Parent Item Name: Quick Release Heli-Utility-Basket™ Long, HD Lid, Spacepod™/Squirrel Cheek Comp.

DART SERVICE INSTRUCTION

**TO AMEND INSTALLATION INSTRUCTIONS D350-607-3 Rev.D,
INSTALLATION INSTRUCTIONS D350-607-4 Rev. C AND
INSTRUCTIONS FOR CONTINUED AIRWORTHINESS ICA-D350-607 Rev. 6**

A	NEW ISSUE			AJS	14.05.16
REV.		DESCRIPTION		BY	DATE
DESIGN	AJS	DART AEROSPACE LTD			
DRAWN	AJS	HAWKESBURY, ONTARIO, CANADA			
CHECKED		DRAWING NO.	REV. A		
MFG. APPR.	N/A	DSI 9699	SHEET 1 OF 2		
APPROVED		TITLE	SCALE		
DE APPR.		LUG REPLACEMENT	NTS		
DATE	14.05.16	COPYRIGHT © 2014 BY DART AEROSPACE LTD THIS DOCUMENT IS PRIVATE AND CONFIDENTIAL AND IS SUPPLIED ON THE EXPRESS CONDITION THAT IT IS NOT TO BE COPIED OR COMMUNICATED TO ANY OTHER PERSON WITHOUT NOT TO BE USED FOR ANY PURPOSE OTHER THAN THAT AUTHORIZED BY DART AEROSPACE LTD

FIGURE 1: INSTALLATION OF D4775-041 FWD STRUT

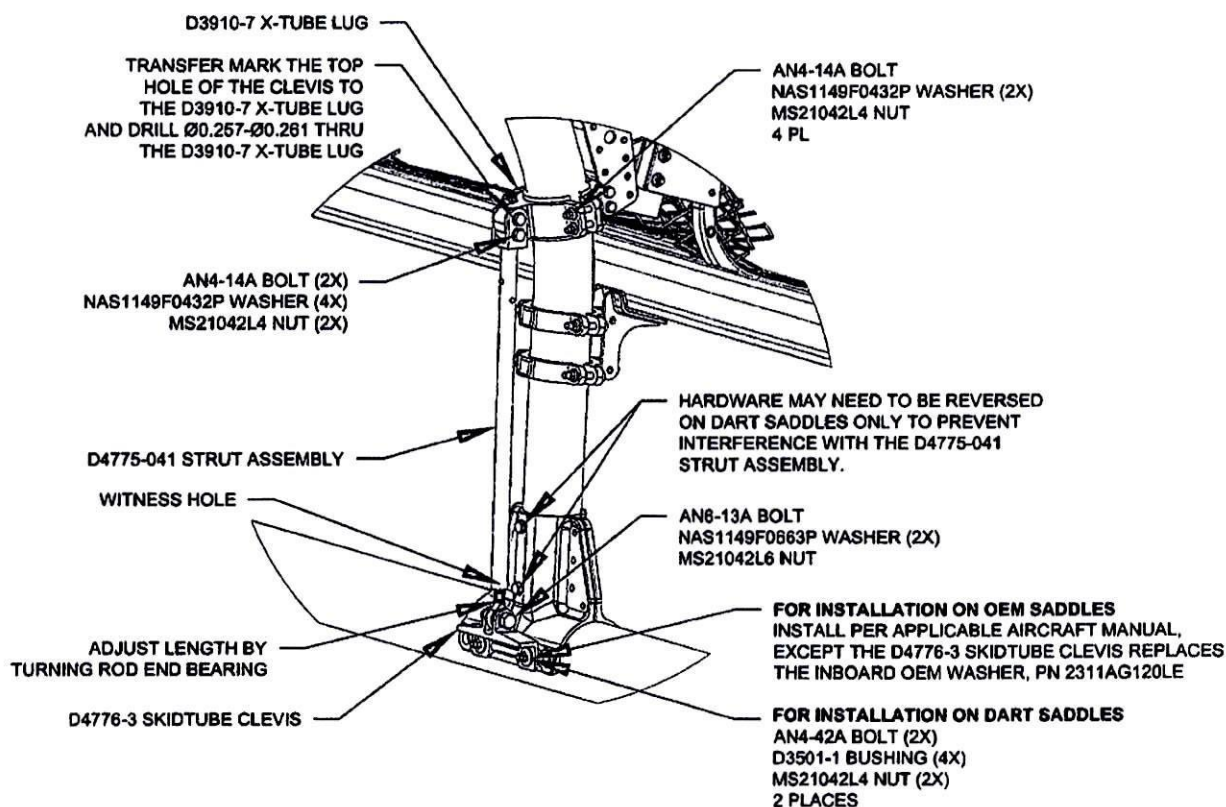
- 3.1 Substitute the Forward Lower D3910-5 X-Tube Lug with the D3910-7 X-Tube Lug as shown in Figure 1.
- 3.2 Install the forward D4775-041 Strut Assembly. Transfer mark from the upper hole on the clevis of the D4775-041 Strut Assembly to the D3910-7 X-tube Lug and drill thru the lug $\varnothing 0.257$ - $\varnothing 0.261$ as shown in Figure 1. Touch up chemical conversion coating per MIL-DTL-5541. Check the witness holes located at the bottom end of the D4775-041 Strut Assemblies to ensure that the thread from the rod end extends past the witness hole.
Torque MS21042L4/-4 nuts to 50-70 in-lbs (5.7-7.9 N-m). Torque MS21042L6/-6 nuts to 160-190 in-lbs (18.1-21.5 N-m).
- 3.3 Complete the installation in accordance with Installation Instructions D350-607-3 Rev. D or D350-607-4 Rev. C.
